FIRE SAFETY INSPECTION REPORT

AMITY DESIGNS LTD.

ACCORD
on Fire and Building Safety in Bangladesh

April 21, 2014

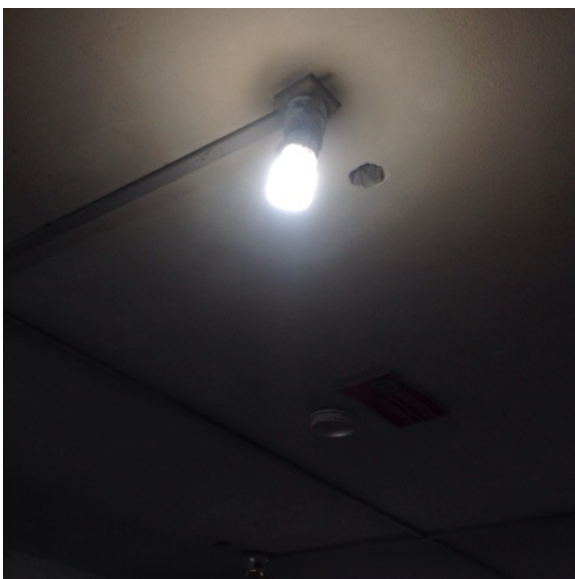
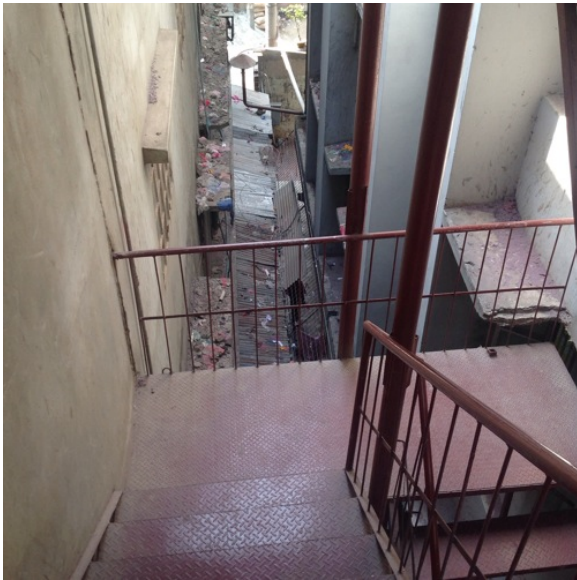
F-8	Egress Lighting	Based on the number and location of emergency lights observed, adequate illumination levels are not anticipated along egress routes on ground or first floor.	Test the emergency lighting system on each floor and provide additional emergency fixtures to provide adequate illumination along the means of egress. Provide a minimum illumination of 10 lux at the floor level within exit stairs and exit discharge paths and minimum 2.5 lux along exit access aisles.	Within 3 months
-----	-----------------	---	--	-----------------

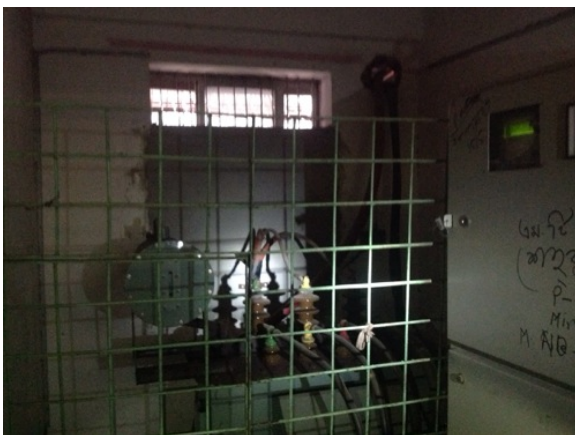
No.	Category	Finding	Recommendation	Remediation Timeframe
F-1	Fire Rated Construction	The exit stairs are not separated from work areas, other spaces on each floor by fire-rated construction.	Provide minimum 1.5-hr fire rated doors and seal all unprotected openings to separate the exit stairs from work areas and other building spaces on all floor levels. Ensure that the fire doors are self-closing and positive latching and that they are provided with fire exit (panic) hardware where serving production floors. If fire doors are required to be held open for functional reasons, provide automatic-closing devices tied to the fire alarm system.	Within 3 months
